Subject: Approval of Plans and Specifications for the Reconstruction of Taxiway F (renamed A) at Oxnard Airport, Including Addenda Nos. 1-2; Waiver of Any Minor Irregularities in the Bid; Award a Contract for the Base Bid Schedule I to Security Paving Company, Inc., in the Amount of \$17,365,009.50, on the Basis of the Lowest Responsive Bid, Conditioned Upon Receipt of a Federal Aviation Administration and/or CalTrans Grants and/or Airport Enterprise Funds Sufficient to Fund Project Costs; Authorization for the Director of Airports, or Designee, to Execute the Subject Contract, if Awarded. (Exhibit 1 is available for review on the Department of Airports website www.vcairports.org)

To: Plan Holders for Improvements to the
Oxnard Airport
Oxnard, California
AIP Project No. 3-06-0179-043-2023
County of Ventura DOA Spec. No. OXR 23-03, Project No. OXR-150

**ADDENDUM NO. 1 TO
CONTRACT DOCUMENTS, SPECIFICATIONS AND PLANS
FOR IMPROVEMENTS TO THE
OXNARD AIRPORT
OXNARD, CALIFORNIA
AIP PROJECT NO. 3-06-0179-043-2023
COUNTY OF VENTURA DOA SPEC. NO. OXR 23-03, PROJECT NO. OXR-150**

**ADDENDUM NO. 2 TO
CONTRACT DOCUMENTS, SPECIFICATIONS AND PLANS
FOR IMPROVEMENTS TO THE
OXNARD AIRPORT
OXNARD,

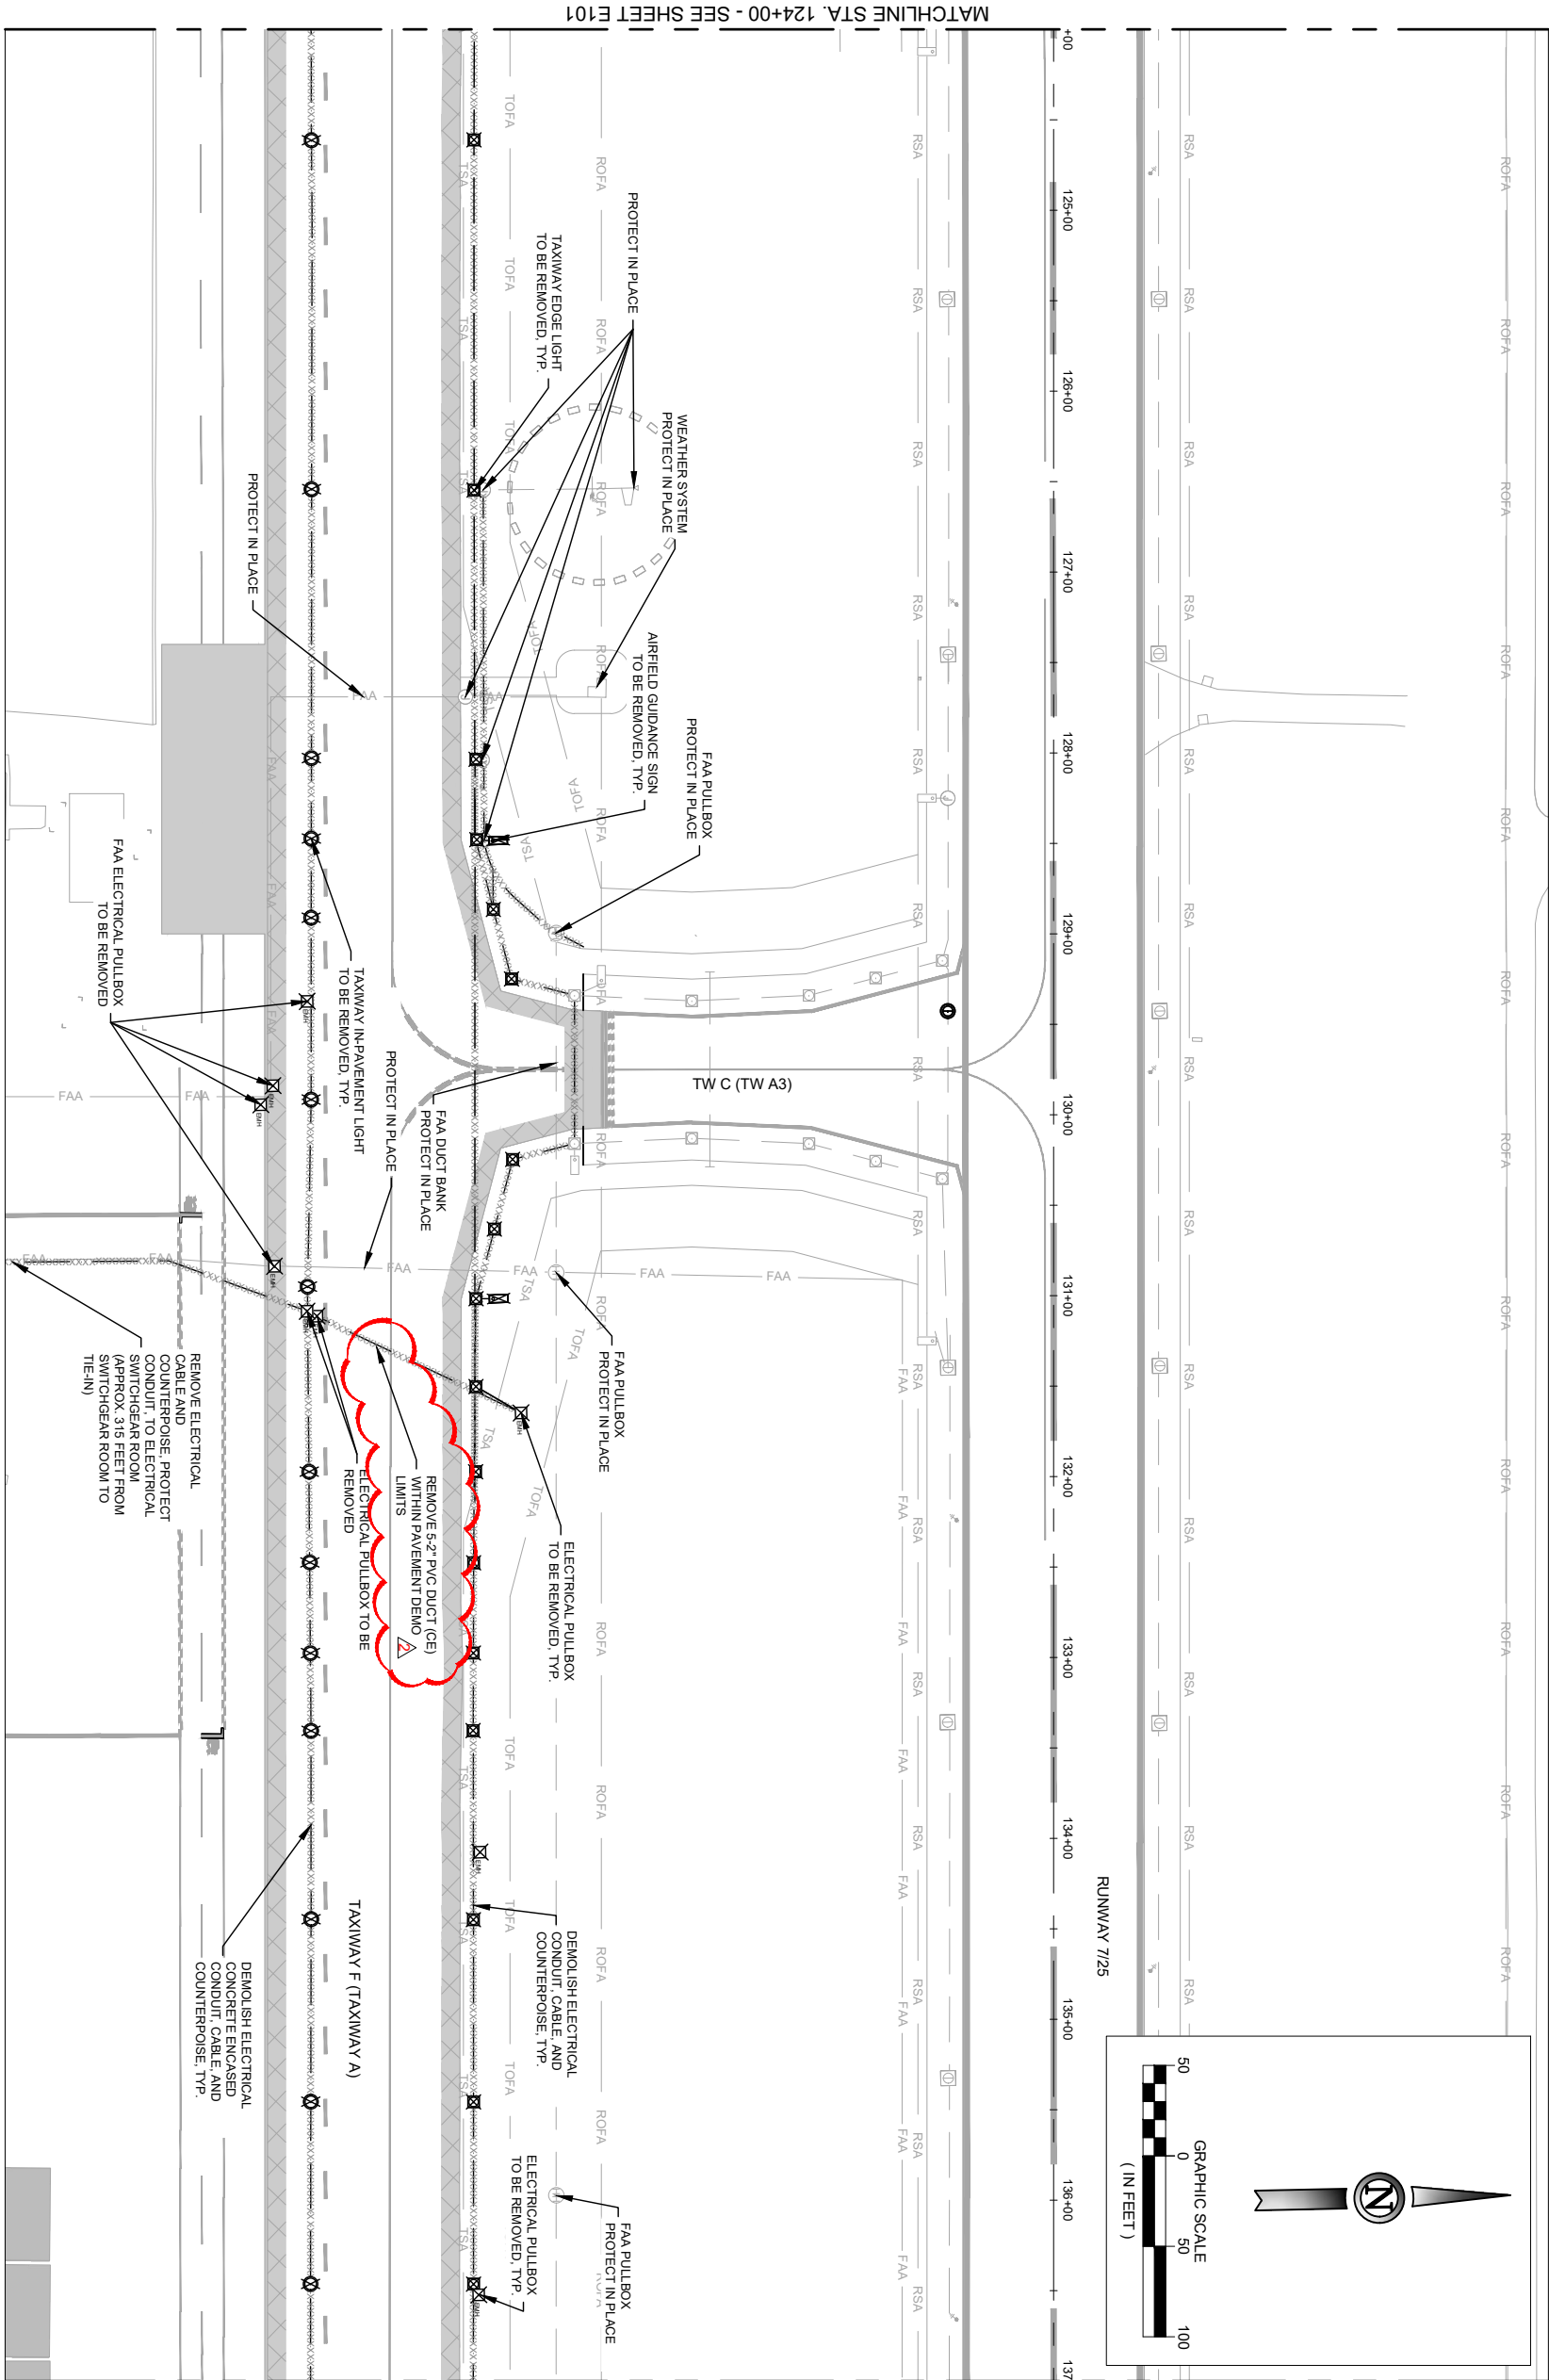
Sheet E102, ELECTRICAL DEMOLITION PLAN STA. 124+00 TO STA. 137+00 RUNWAY 7/25. A note was added showing the demolition of the 5-2" PVC Duct within the pavement demo limits.

- 6) Question: On Plan Sheet E102, please clarify means and methods for removal of conduit and wire crossing under existing Taxiway F (Taxiway A).

Answer: This duct bank shall be removed during the project. The limits of removal shall be within the pavement removal limits.

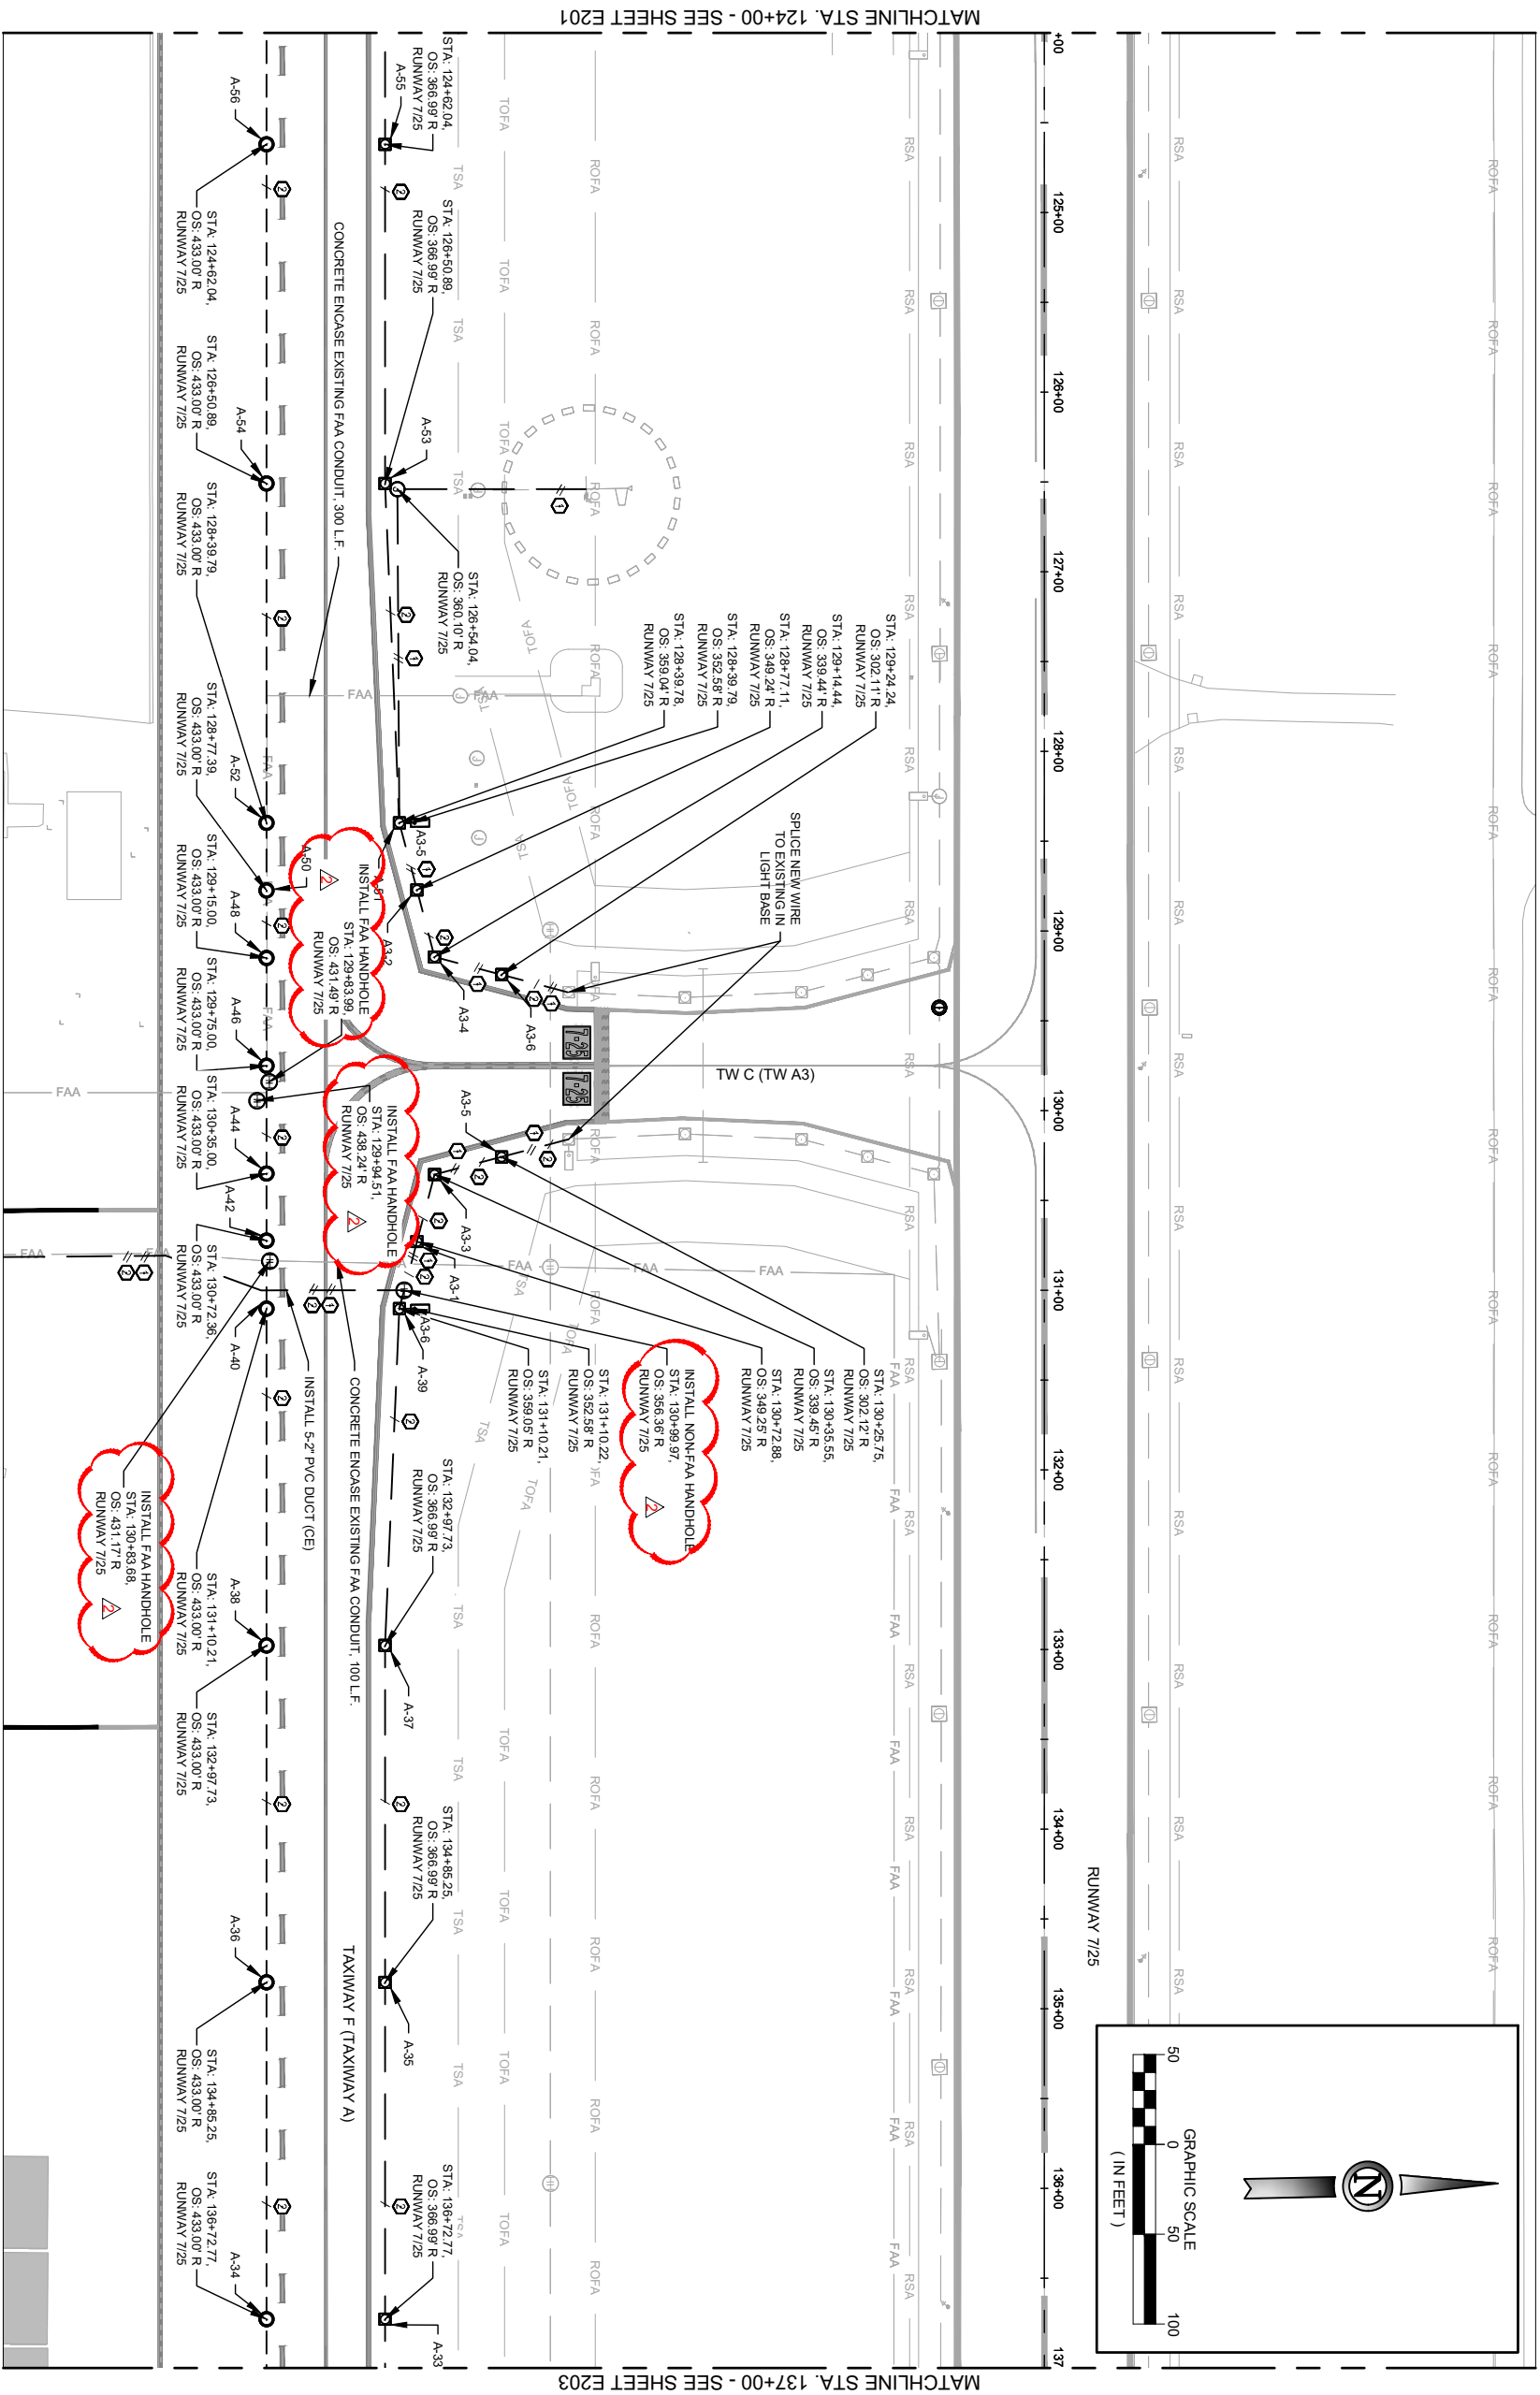
Sheet E202, ELECTRICAL LAYOUT PLAN STA. 124+00 TO STA. 137+00 RUNWAY 7/25. The callouts for the pullboxes were updated to show the FAA and NON-FAA electrical pullboxes.

- 7) Question: On Plan Sheet E202, is the 5-2" PVC Duct (CE) to be directionally bored under the existing pavement?

Answer: The 5-2" PVC Duct (CE) will not be directionally bored under the existing pavement. This duct will be installed within the proposed pavement limits and tie to the existing duct bank at the edge of the limit.

ELECTRICAL DETAILS				SHEET NAME	
AIP PROJECT NO.	JVIATION PROJ. NO.	SPEC. NO.	COUNTY PROJ. NO.	E251	
3-06-0179-043-2023	2023 OXR-01	DOA 23-03	OXR-150	SHEET NO.	87 of 89
				DRAWING NO.	1672-DOA

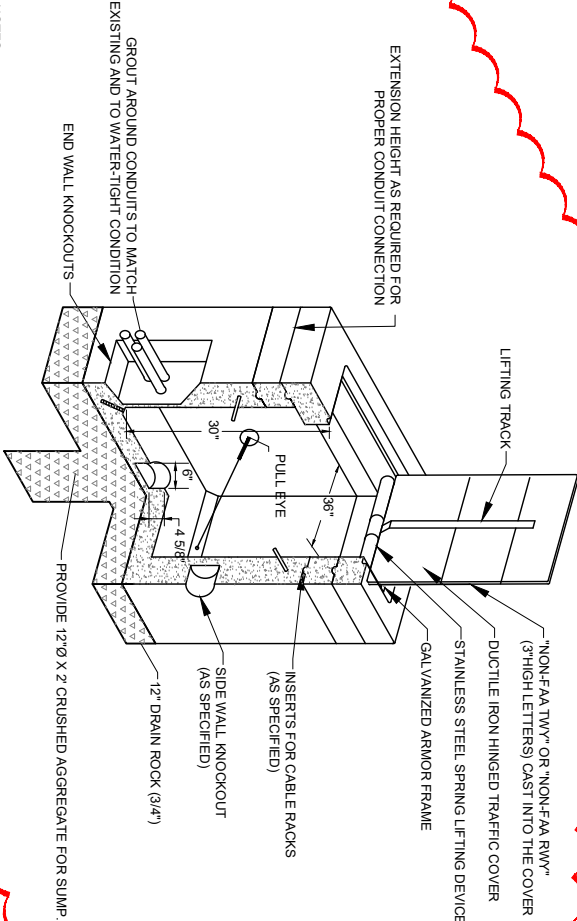
Sheet E251, ELECTRICAL DETAILS. Detail 6 was added to the sheet to show the NON-FAA Pullbox.

ELECTRICAL DETAILS	SHEET NAME		
	E252		
	SHEET NO.		
	88 of 89		
	DRAWING NO.		
	1673-DOA		
AP PROJECT NO.	JWATTON PROJ. NO.	SPEC. NO.	COUNTY PROJ. NO.
3-06-0179-043-2023	2023 OXR 01	DOA 23-03	OXR-150

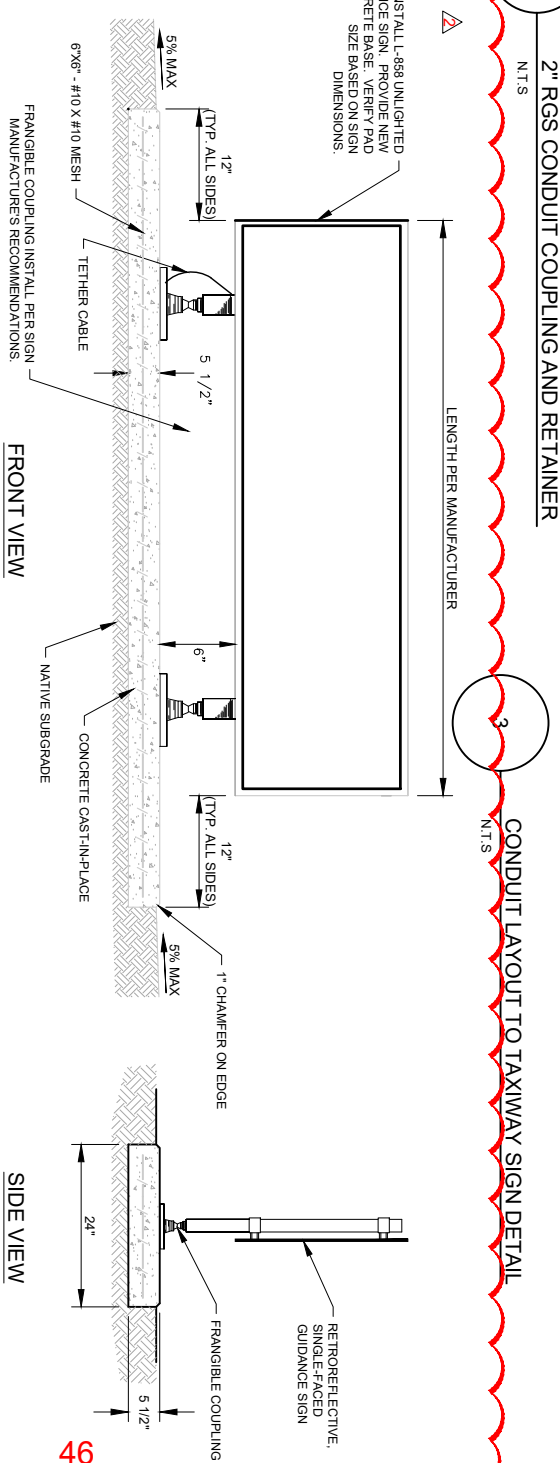
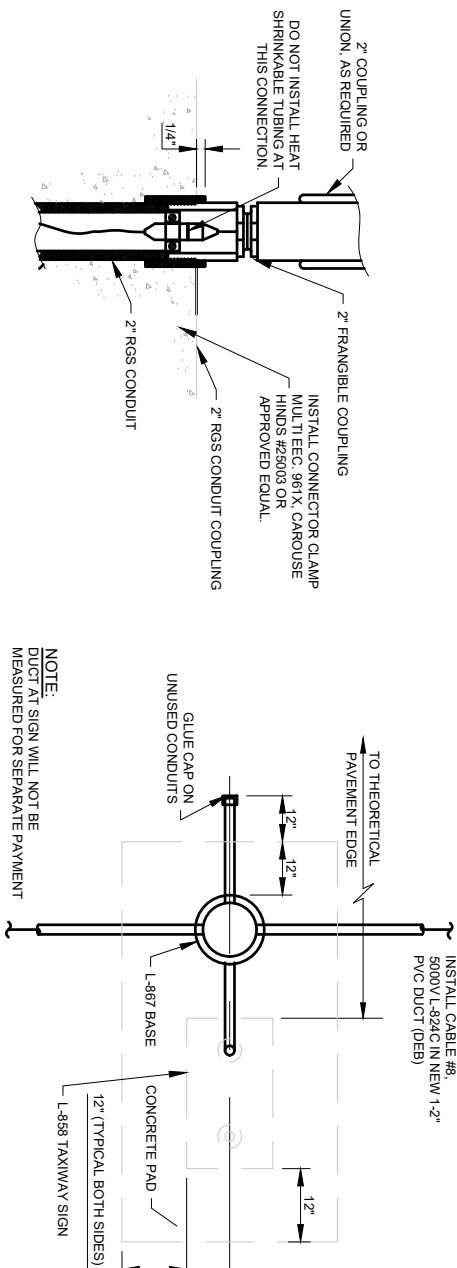
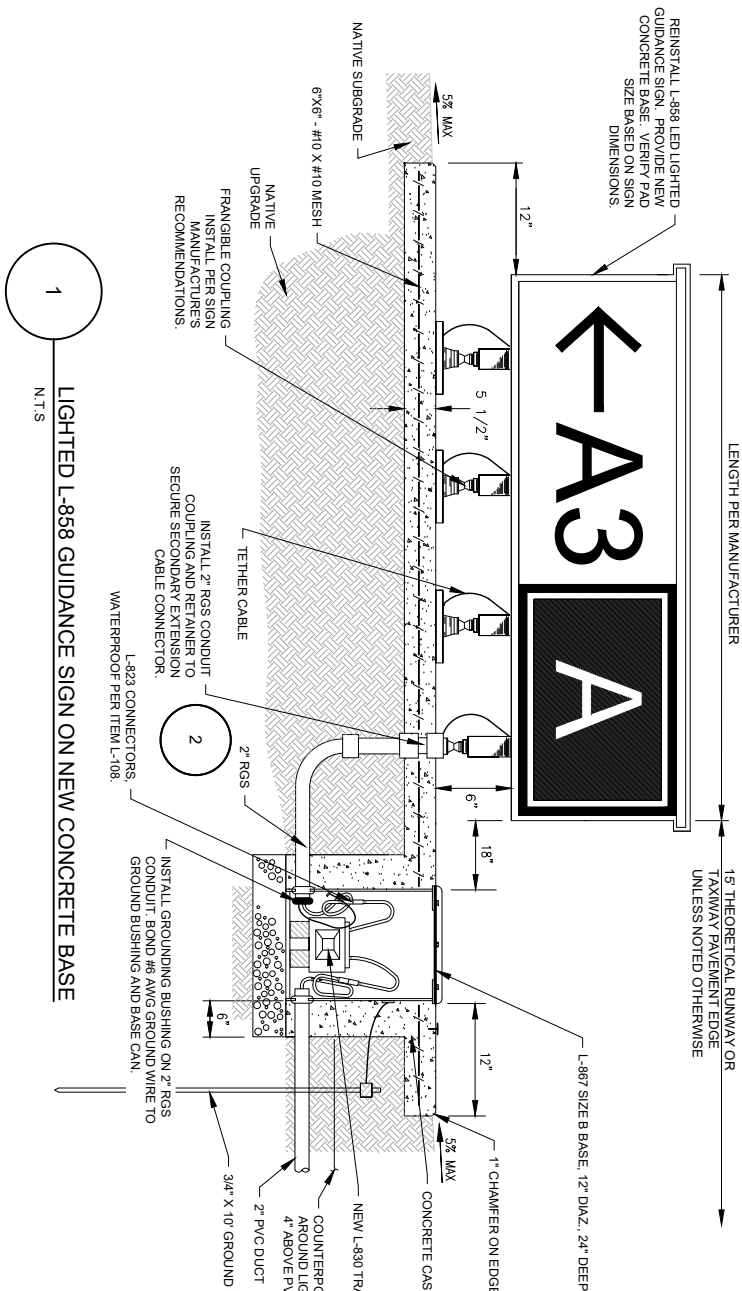
Sheet E252, ELECTRICAL DETAILS. Detail 4 was added to the sheet to show the reinstallation of the unlighted billboard sign.
